JOINT REGIONAL PLANNING PANEL - ASSESSMENT REPORT

JRPP Reference Number	2012SYW096
Development Application Number	DA-410/2010/A
Proposed Development:	<p>Modification to Development Consent DA-410/2010 pursuant to Section 96(2) of the Environmental Planning & Assessment Act 1979. The modification seeks to:</p> <ol style="list-style-type: none">1. Amend the car parking design and relocate the car parking area.2. Extend the hours of operation to permit 24 hour operation of the facility.3. Change the layout of the stockpile bins.4. Increase the platform area of the processing area for recovered aggregate.
Address	Lots 4 & 5 DP 24315, Nos 65 – 75 Yarrawa Street (and Illaroo Road) Prestons
Applicant:	Kypter Pty Ltd
Land Owner:	Sydney Invitation Futurity Pty Ltd & Rentail Pty Ltd

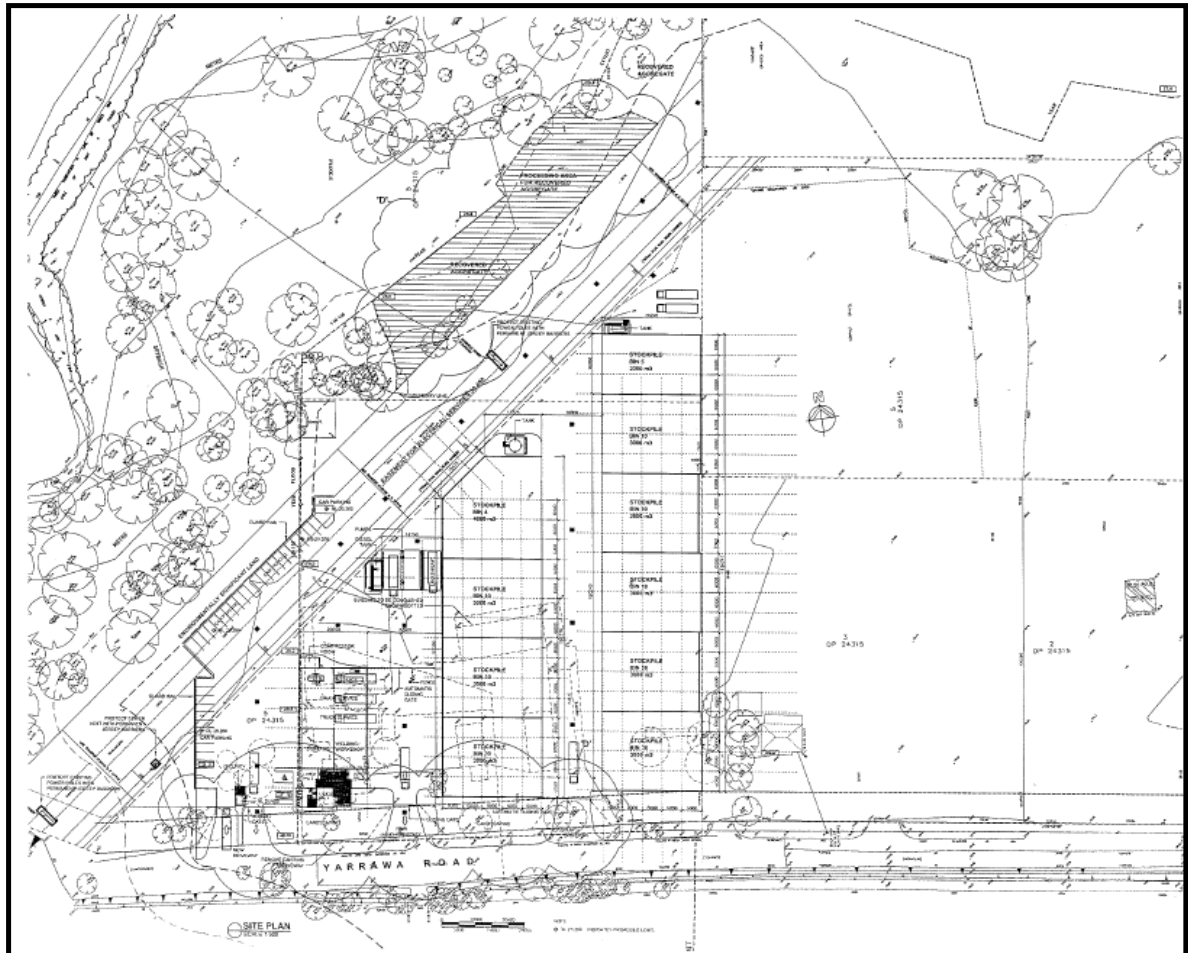
Previous activity on this site has resulted in the depositing of fill within the electrical easement, up to 1 metre higher than the safe limits for the proposed activities carried out under electrical conductors. This material needs to be removed.

The excavated material has to be deposited elsewhere on the site without impacting on flood storage levels as required by Condition No.6 of the Consent.

The excavated material from under the conductors and the wetland basins is proposed to be deposited in the area of the recovered aggregate stockpile platform. This would increase the platform area by approximately 1,500m². The applicant submits that this would not reduce flood storage levels and that the excavated material from the site would exceed the amount of fill proposed to be deposited in the current flood storage area. Flood storage is likely to increase as a result of this proposal.

Council's Flood Engineer advises that the site is located adjacent to Cabramatta Creek and is affected by flooding under the 1% Annual Exceedance Probability (AEP) event. In the approved proposal (DA-410/2010), the proposed processing area for recovered aggregate was located outside 1% AEP flood extent. However, in the modified proposal, the processing area for recovered aggregate has been extended to the 1% AEP flood extent, which has the potential to cause adverse impact. Accordingly, the modification 'D' is not supported.

PROPOSED AMENDED SITE PLAN

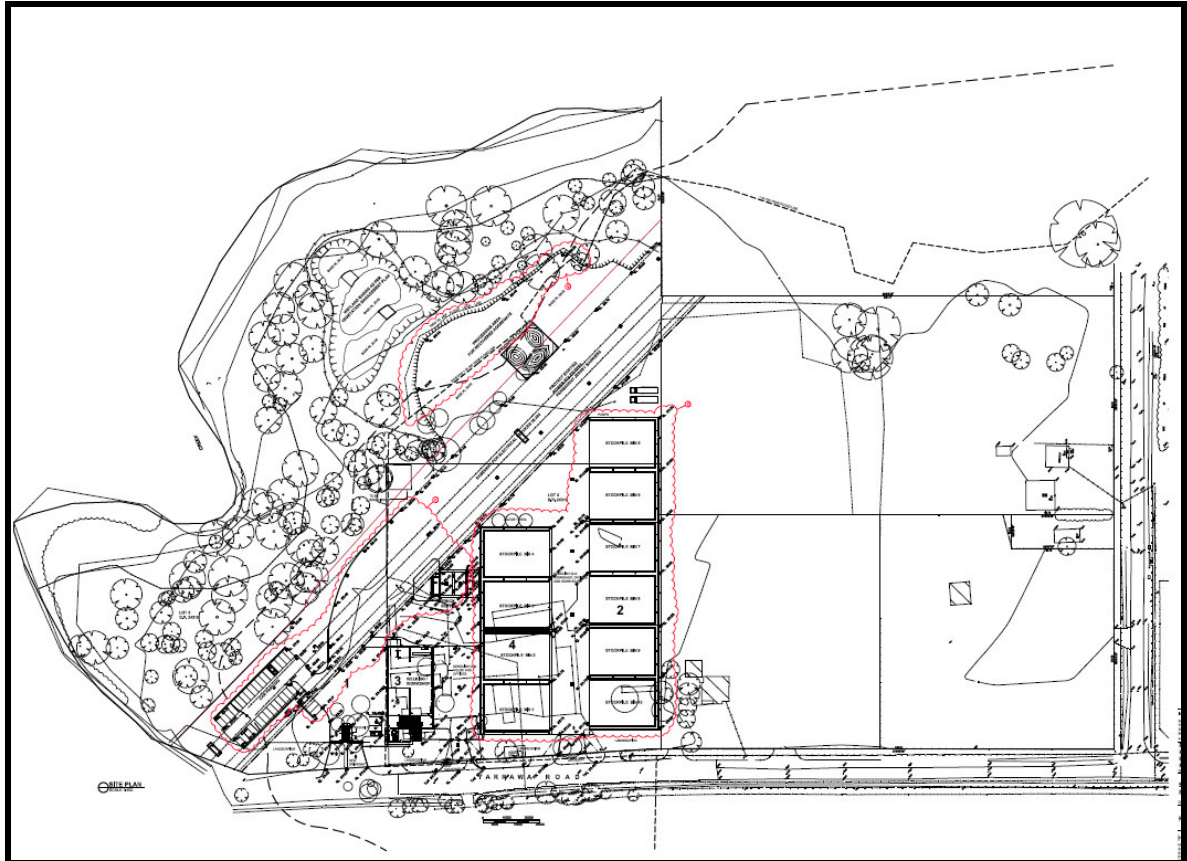
The 39 space car parking area and associated driveway as approved are located in the 30.48 metre wide electrical easement traversing the site. An application to carry out work within the easement was made to Endeavour Energy by the applicant, which was refused on the grounds that there was insufficient clearance under the existing electrical conductors.

The proposed new car parking area provides for the same number of spaces and remains located under the electrical conductors within the electrical easement, but closer to one support structure. The applicant submits that this area has not currently been identified for landscaping or for any other purpose and is within the Bushfire Inner Protection Area. For this reason, this part of the industrial site has not been included in the Vegetation Management Plan.

The car parking layout is essentially being moved along the electricity easement from a mid-span location between two transmission line supports to a location closer to one support. This location is better able to obtain adequate conductor safety clearance and meet Council's minimum flood level requirements. The area is already cleared and thus the altered car parking location would have minimal environmental impact.

However, a significant portion of this cleared area is zoned E2 Environmental Conservation. This zoning does not permit the use of a 'resource recovery facility.' Thus, a significant portion of the car park would now encroach on E2 zoned land and is not permitted. *Clause 5.3 Development near Zone Boundaries* of LLEP 2008 does not apply to E2 zoned land and cannot be utilised to achieve flexibility. Therefore, this component of the modification must be refused.

The layout for the stockpile bins shown on the approved DA drawings consisted of 8 covered bins which were approximately 720m² each (5760m² in total) and two irregular sized uncovered bins (Nos. 4 + 5) which were approximately 856m² and 540m² respectively (Total 7156m²).

The proposal is to change the layout to make each bin a similar size of approximately 690m² with a total area under cover of 6,900m² and to add water tanks for rainwater recycling and dust control.

The proposed changes do not generate any adverse impact and when completed, the modified development would be substantially the same as the originally approved development.

1. The Joint Regional Planning Panel refuses the subject Section 96 Modifications identified as "A", "B" and "D" of Development Application DA-410/2010.
2. The Joint Regional Planning Panel approves the subject Section 96 Modification identified as "C" of Development Application DA-410/2010.
3. An amended plan to be submitted by the applicant for approval stamping showing the proposed modification of the storage bins minus the proposed car park and processing platform area modifications which are recommended for refusal.
4. Persons who made a submission with respect to the proposed development are notified in writing of the JRPP's decision.
